**From:** Scala, Mary Joy  
**Sent:** Monday, March 21, 2016 4:23 PM  
**To:** 'Russell Skinner'  
**Subject:** BAR Action – March 15, 2016 – 36 University Circle

BAR 16-03-04  
36 University Circle  
Tax Parcel 06009200  
Margaret Nelsons, Owner/Russell Skinner, Applicant  
Renovations: addition of a rear garage, two front dormers, enclose rear porch and update overall infrastructure

**CITY OF CHARLOTTESVILLE  
BOARD OF ARCHITECTURAL REVIEW  
STAFF REPORT  
March 15, 2016**

## 36 University Circle Project

**7/8" SDL  
W/Spacer Bar**

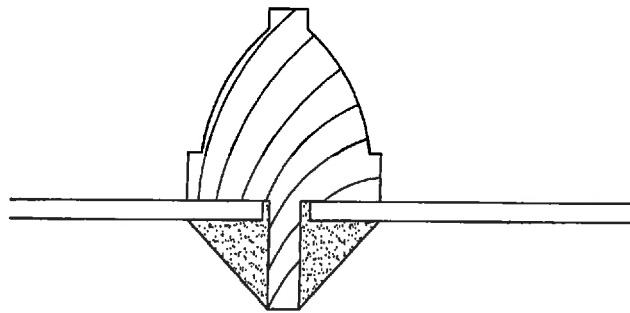
The BAR will ask for cut sheets and more details on proposed windows. Will they be wood or aluminum clad with SDL's? Will any of the existing window sizes change? Please be prepared to justify replacing the old windows, perhaps with photos of conditions beyond repair.

We would like to replace the existing sashes with new wood Marvin double pane sashes. The rails and stiles will be 1 5/8" wide as opposed to the existing which are 1 1/2". Attached is a drawing of the existing typical muntin and a cut sheet of the closest Marvin SDL muntin, as well, as, a Marvin window section. Currently the house has unfinished aluminum storm windows, which at unattractive. We are going to insulate the house and hope to remove the storm windows and install double pane sashes for energy efficiency and improved appearance.

**S1.1**

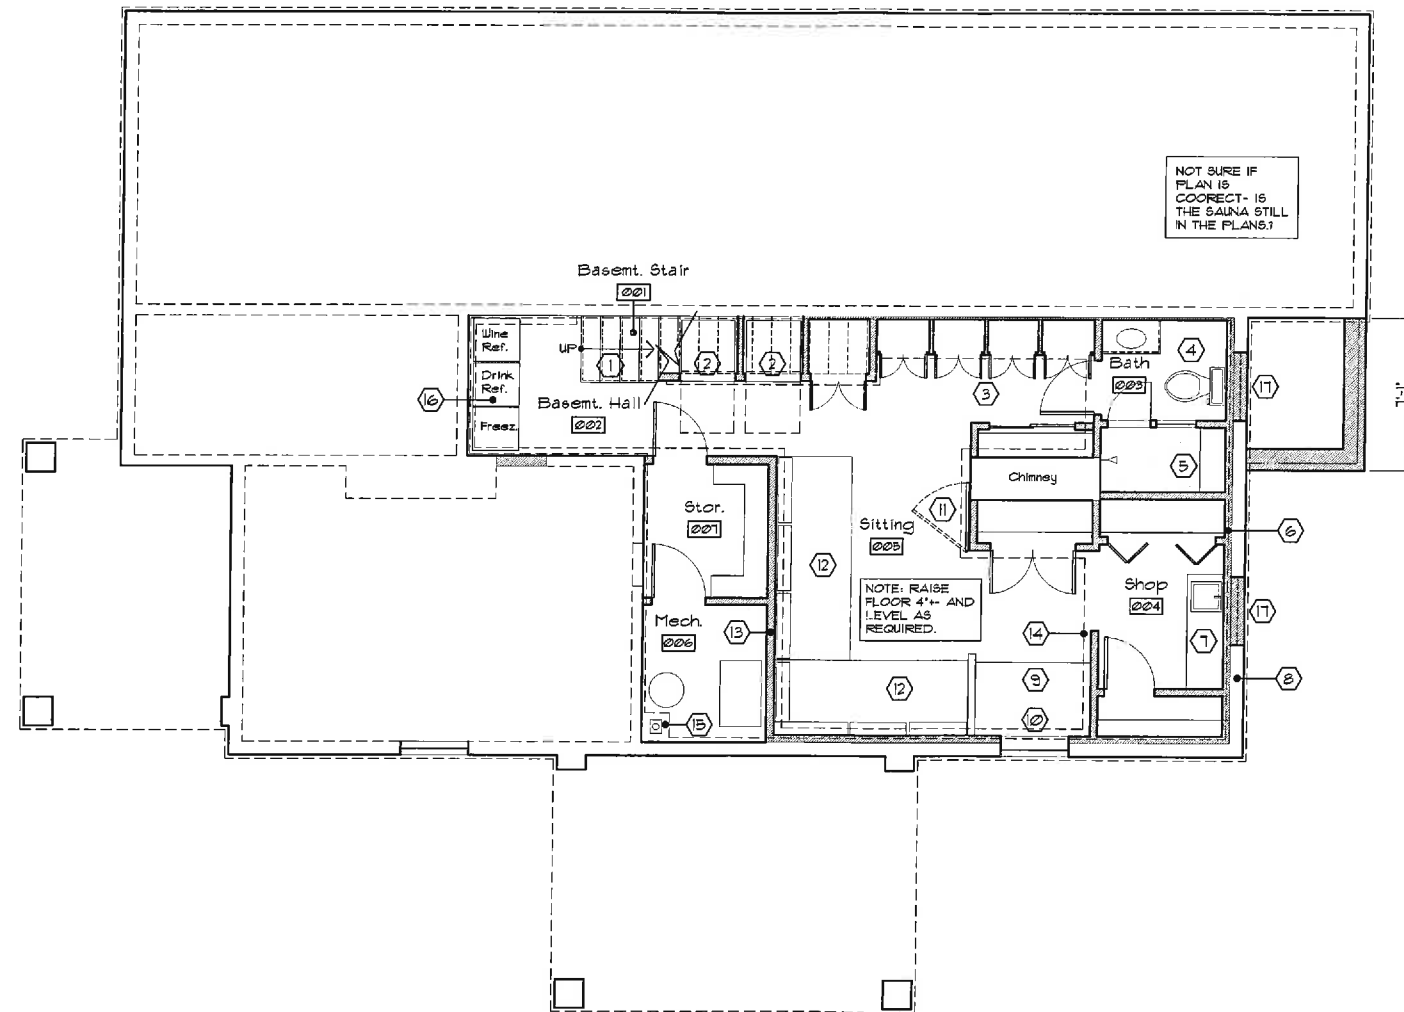
NOT SURE IF  
PLAN IS  
CORRECT- IS  
THE SAUNA STILL  
IN THE PLANS?

A3.0

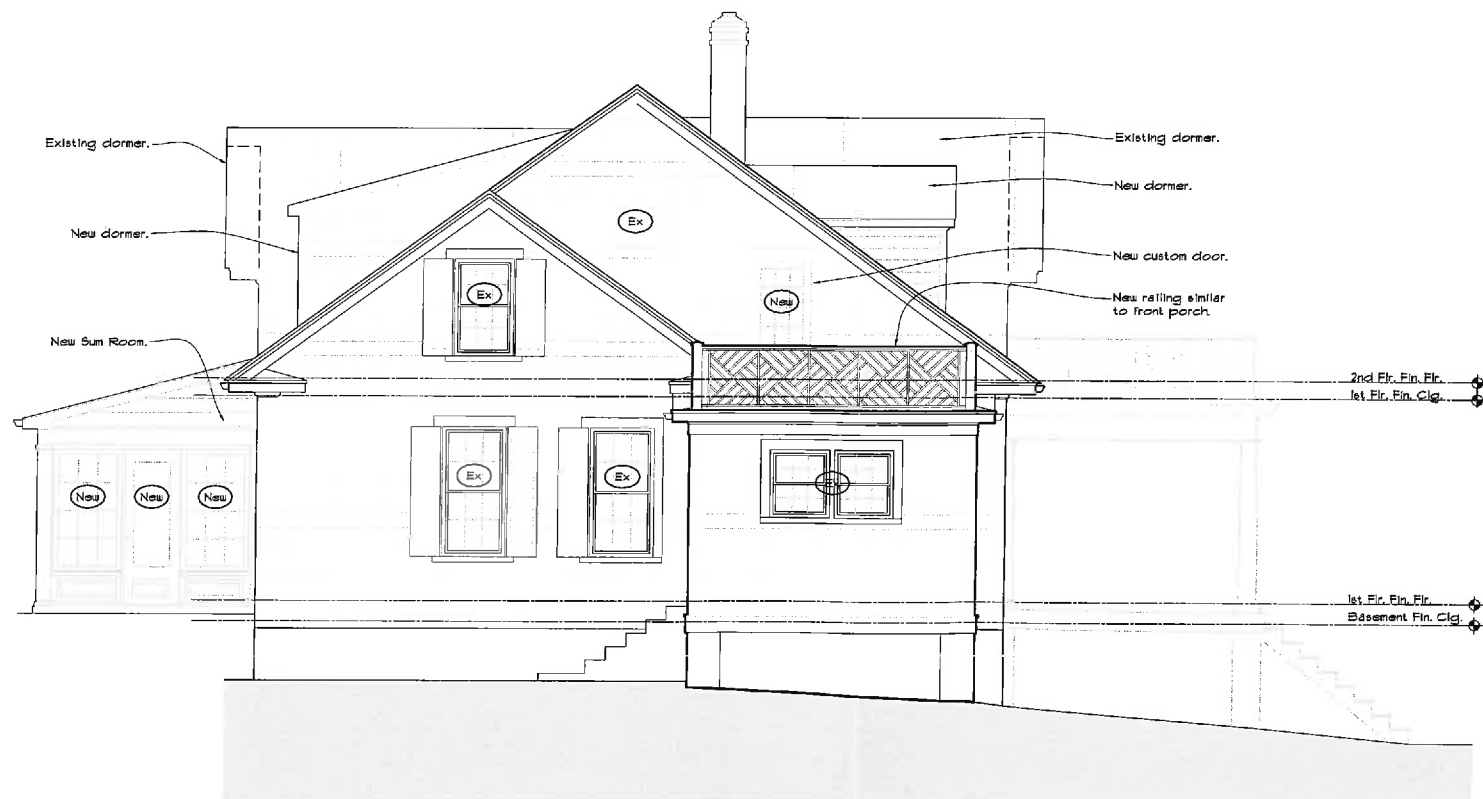
**The BAR approved the application as submitted, aside from the design of the two dormers on the front façade to come back later (probably when the siding decisions possibly come back) and additional information on the condition of the existing windows, particularly on the street side façade, to come back to the BAR in the future. (6-0-1, with Balut abstained)**

The proposed changes are sympathetic to the existing dwelling. Based on the guidelines, the points of discussion would be adding the front dormers and replacing all the windows.

G1.1

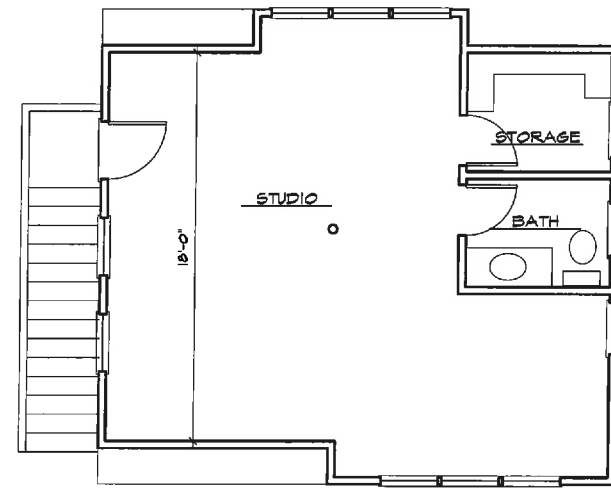
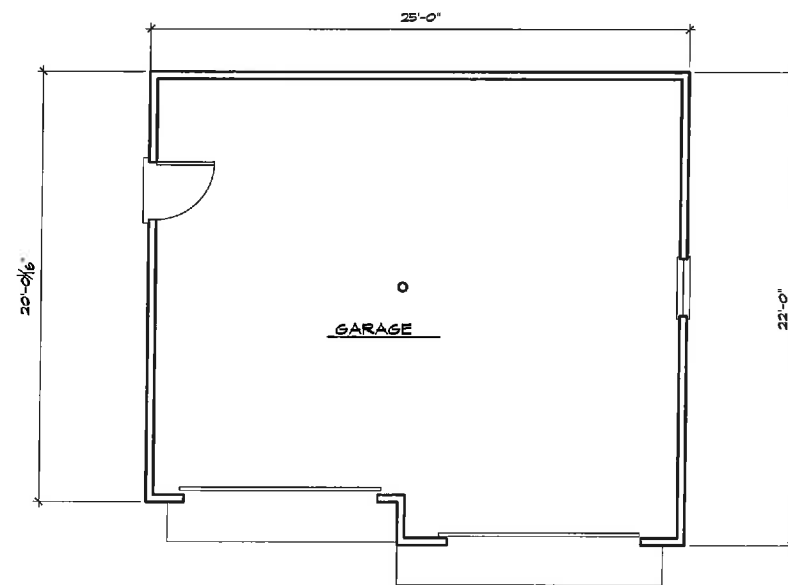
Do you have an existing photo of the window to be changed to a door above office? Will the width be maintained? I need a list of materials proposed for the new garage.

Attached there are 3D views of the garage, an elevation with the materials called out and a photograph of the proposed garage doors.
